TITLE: TagV2p2_r4		REV: 3
嘉立创EDA	Company: Project CETI	Sheet: 1/9
	Date: 2023-05-12	Drawn By: Shreya Singh

CHANGE LOG

NOTES, ISSUES AND TODO LIST

Front End Channels (A & B)

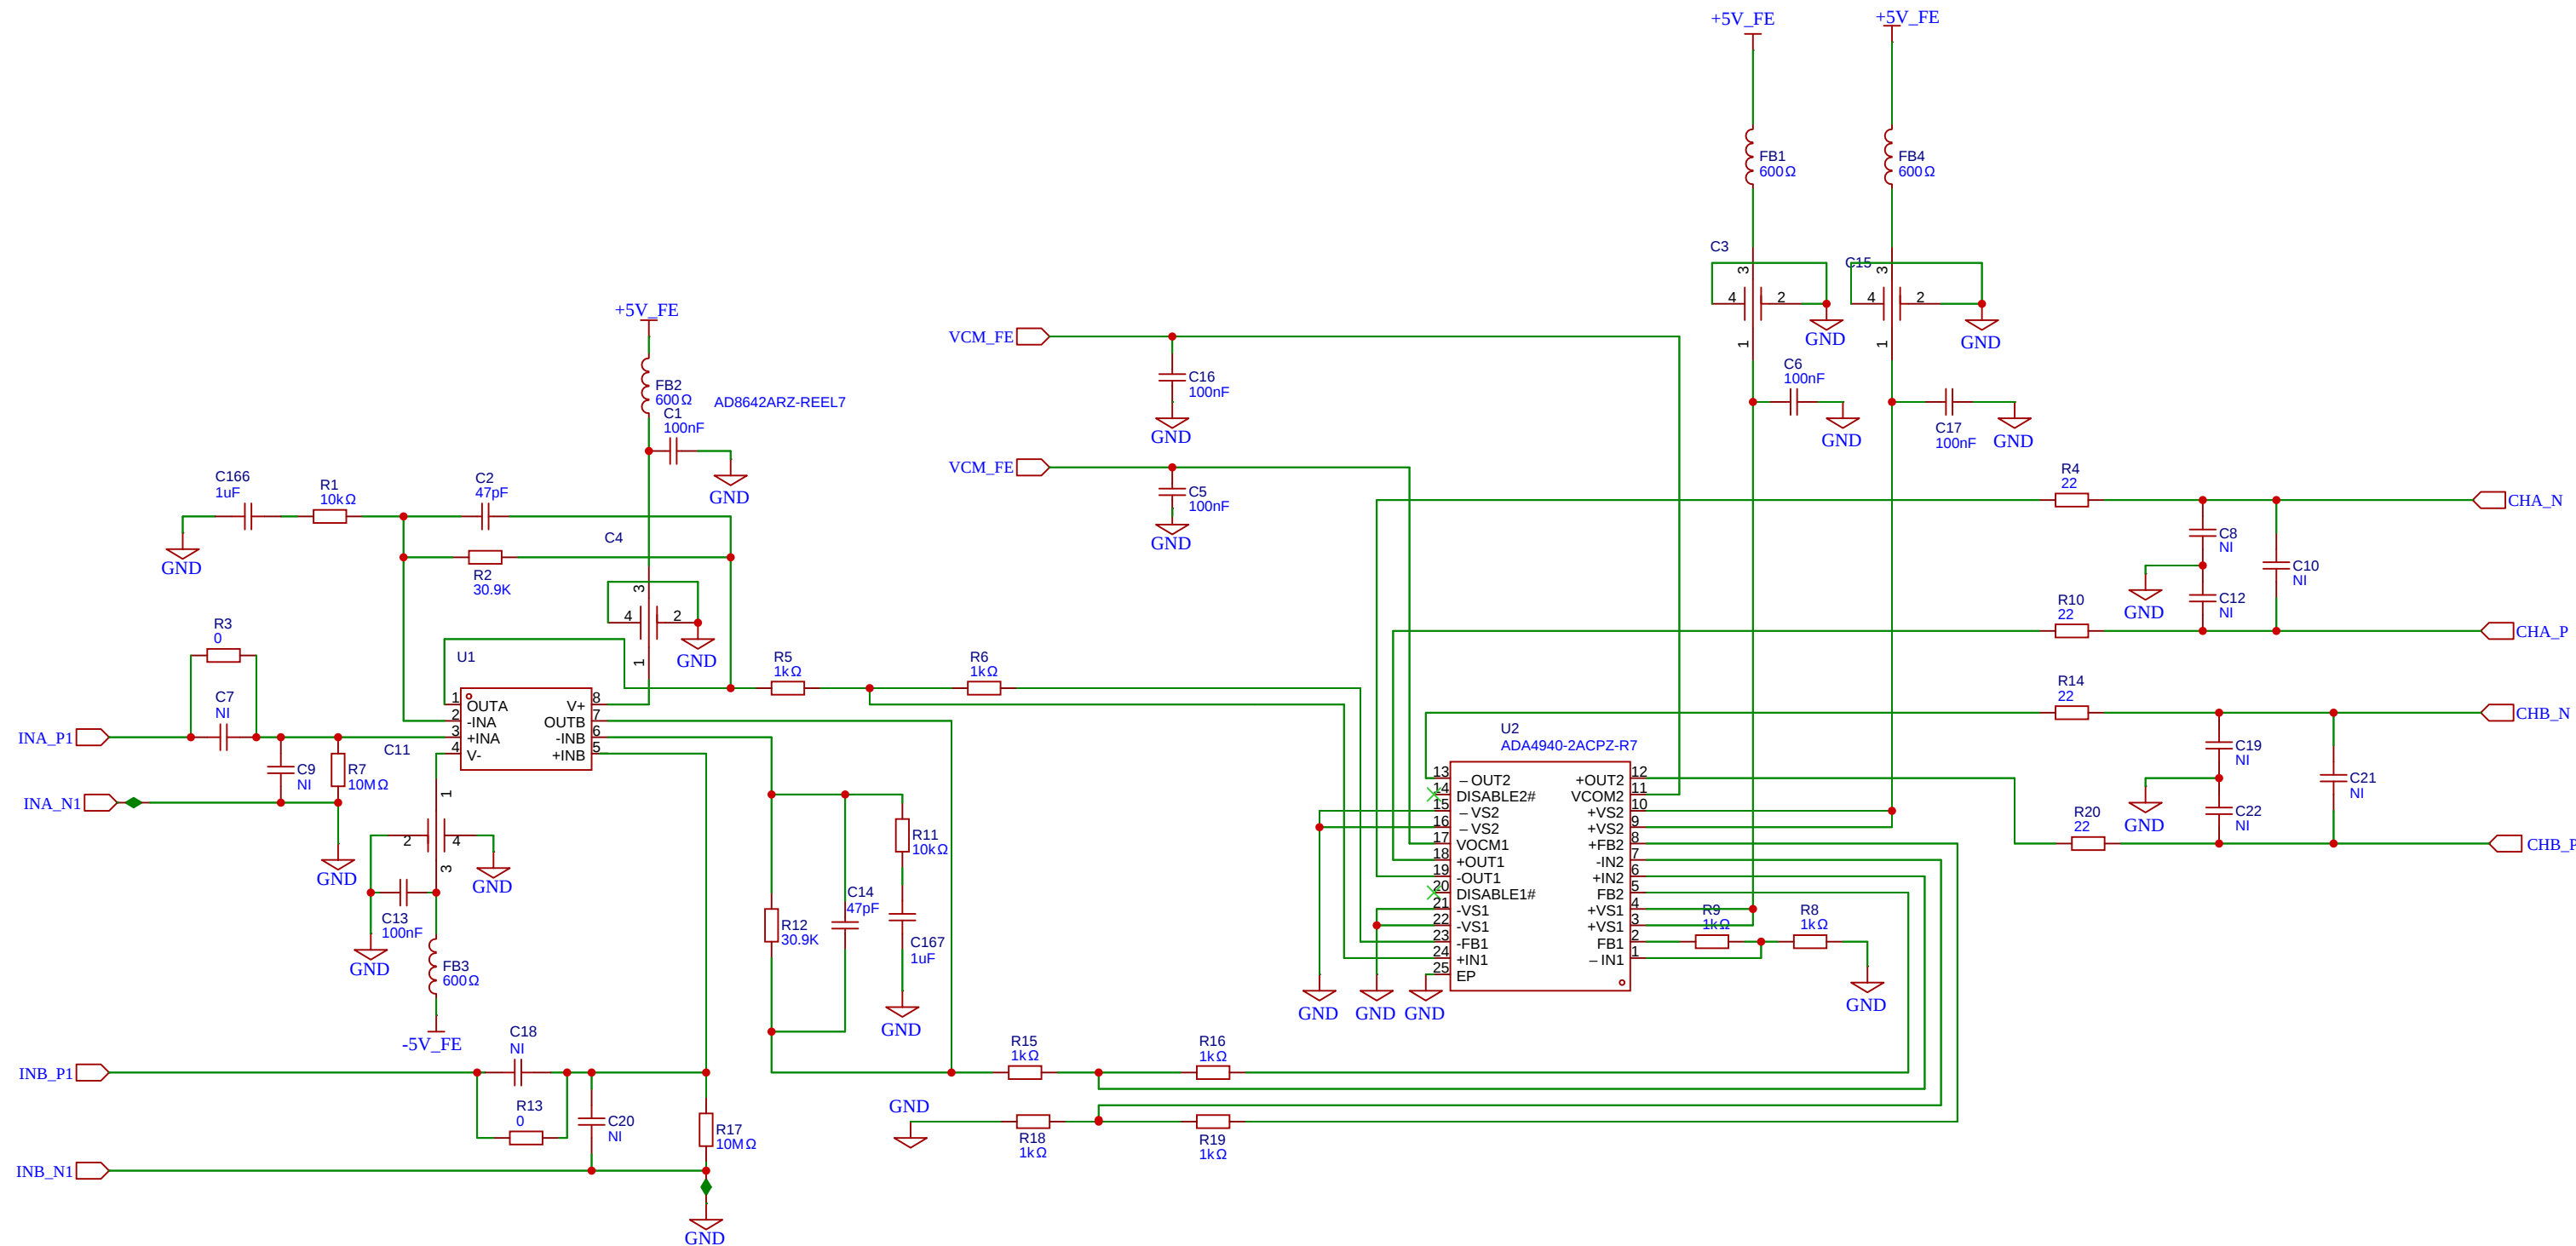
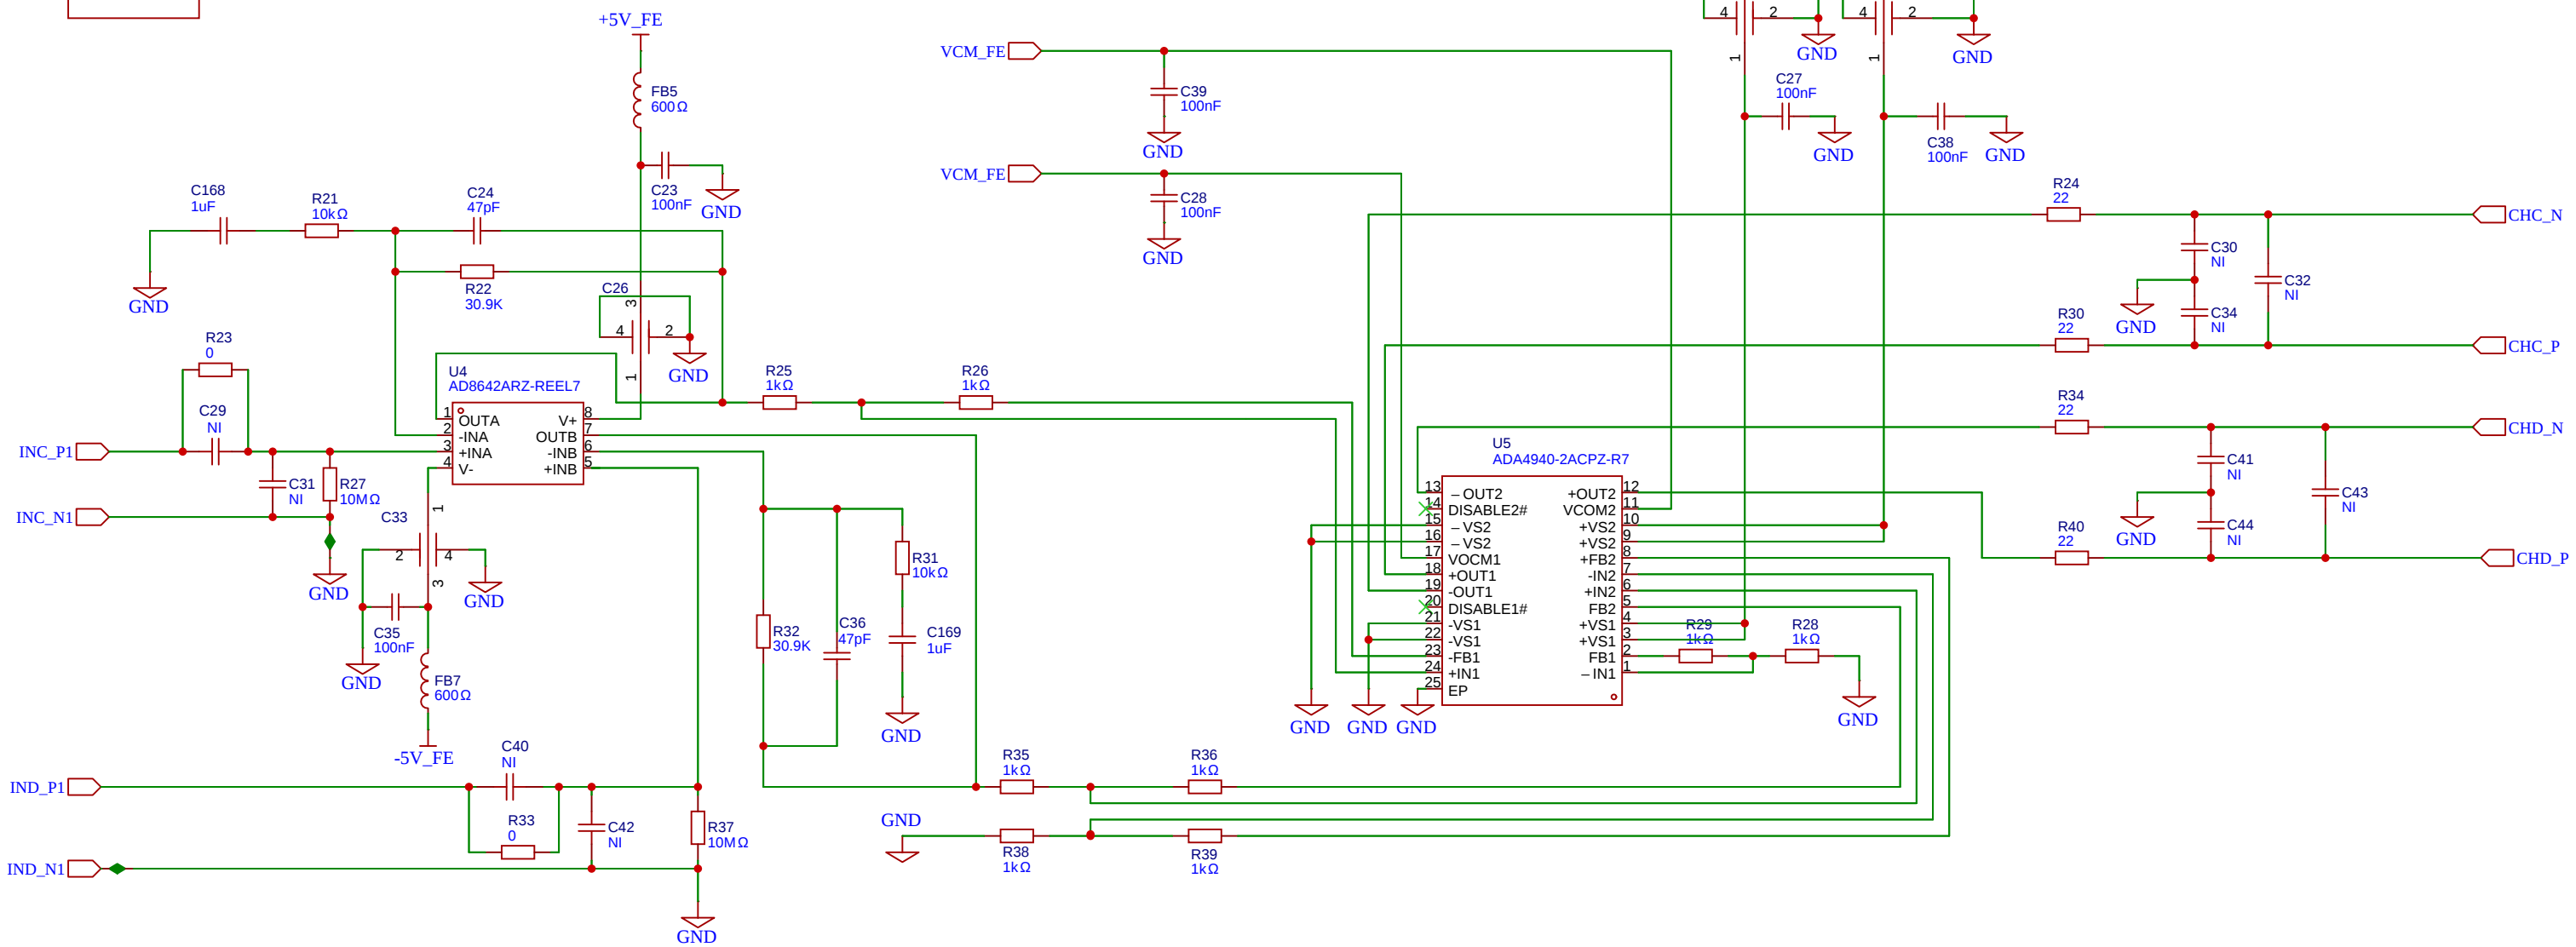
- REV 4 10/19/23 CUMMINGS:
- * CONNECTED GPIO13 TO RF 3V3 SO SW CAN TURN IT OFF AND ON.
 - * ADD PULL UP ON RECOVERY BOOT_EN LINE
 - * DEPTH SENSOR POSITION ADJUSTED IN LAYOUT (MICHAEL)
 - * UPDATED FRONT END TO ADD HPF POLE
 - * E13 SHOULD NOT BE INCLUDED IN BOM. REMOVED (MATT 10/23/23)

24-BIT 4-CHANNEL ADC

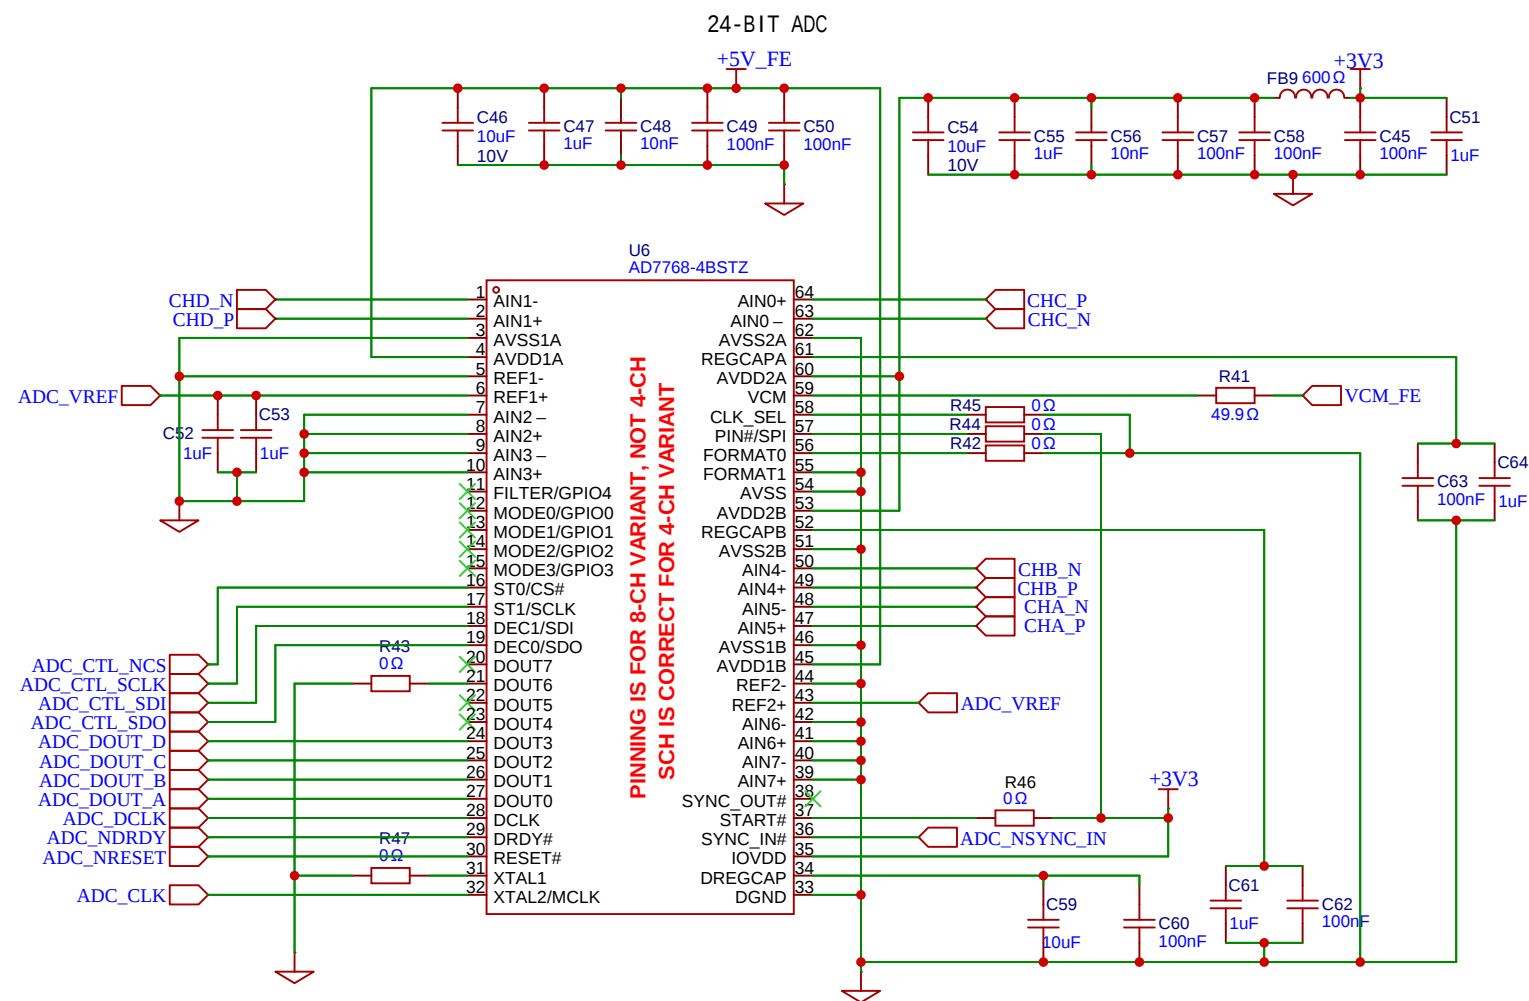
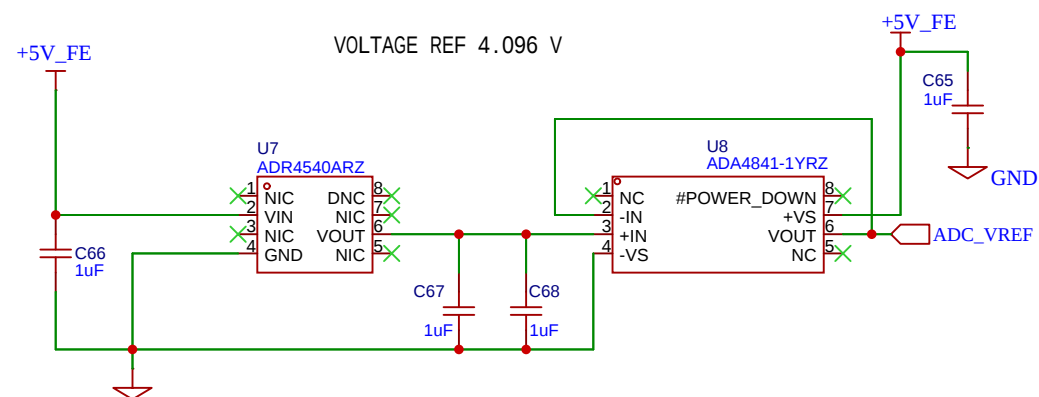
DRAW OP AMPS AND COMPARATORS AS FUNCTIONAL SYMBOLS NOT BOX SYMBOLS
ADC SYMBOL IS DRAWN AS THE 8-CH INCORRECT PIN LABELS FOR 4-CH
CETI/SEAS LOGO ON TEMPLATE
FIX BMS IC SO PIN NAMES ARE LEGIBLE
